PRODUCT/PROCESS CHANGE NOTICE (PCN)

PCN #: A1910-01	DATE: 29-Oct-2019	MEANS OF DISTINGUISHING CHANGED DEVICES:
Product Affected: FCCSP-53, FCCSP-253 (Refer to attachment II for affected part#)		<input type="checkbox"/> Product Mark <input checked="" type="checkbox"/> Back Mark Traceable through lot# <input type="checkbox"/> Date Code <input type="checkbox"/> Other
Date Effective: 29-Jan-2020

ATTACHMENT I - PCN # : A1910-01

Assembly Sample Open/Short Test and 3-sigma Trigger Limit Disposition Flow

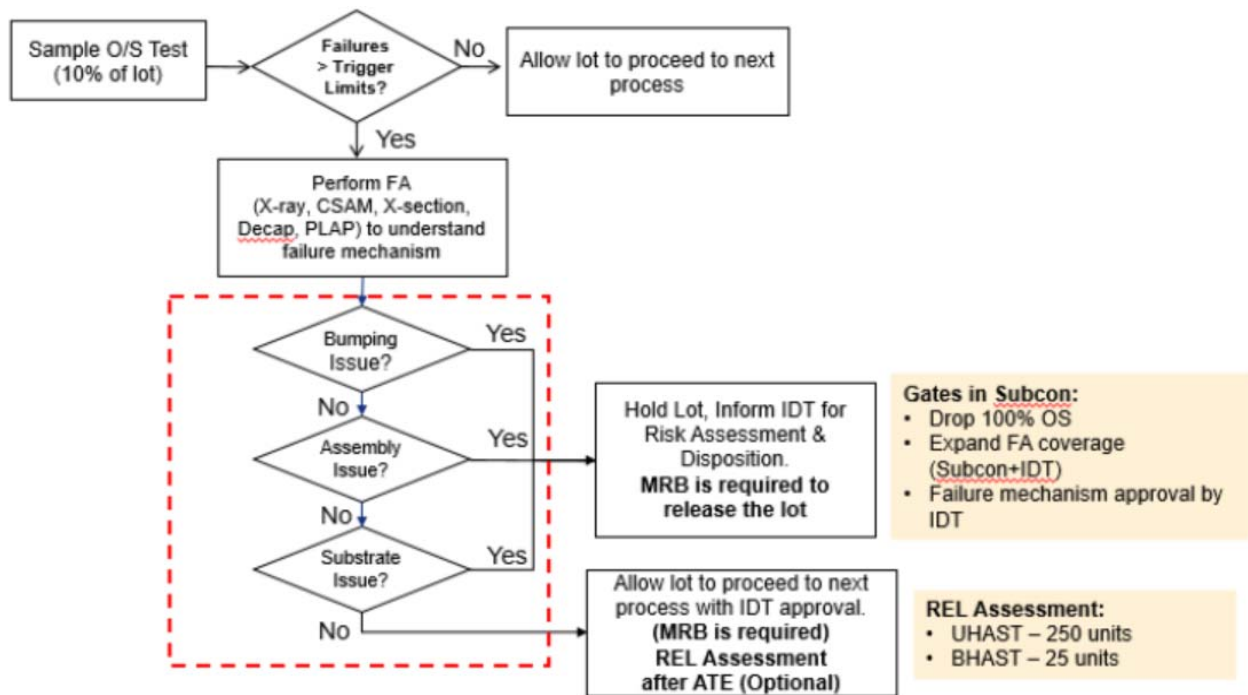
This notification is to advise our customers that Sample Open/Short test will be introduced at Assembly Process at Amkor Korea and Stats Chippac, Korea at the request of the customers.

Assembly process flow as detailed below.

Bumping Issue: Missing bumps, Open bumps, UBM Defects, RDL defects.
 Assembly Issue: Bump bridge, Missing bump, Delamination, Die Crack.
 Substrate Issue: Shorting Trace, Open Trace, Open Via.
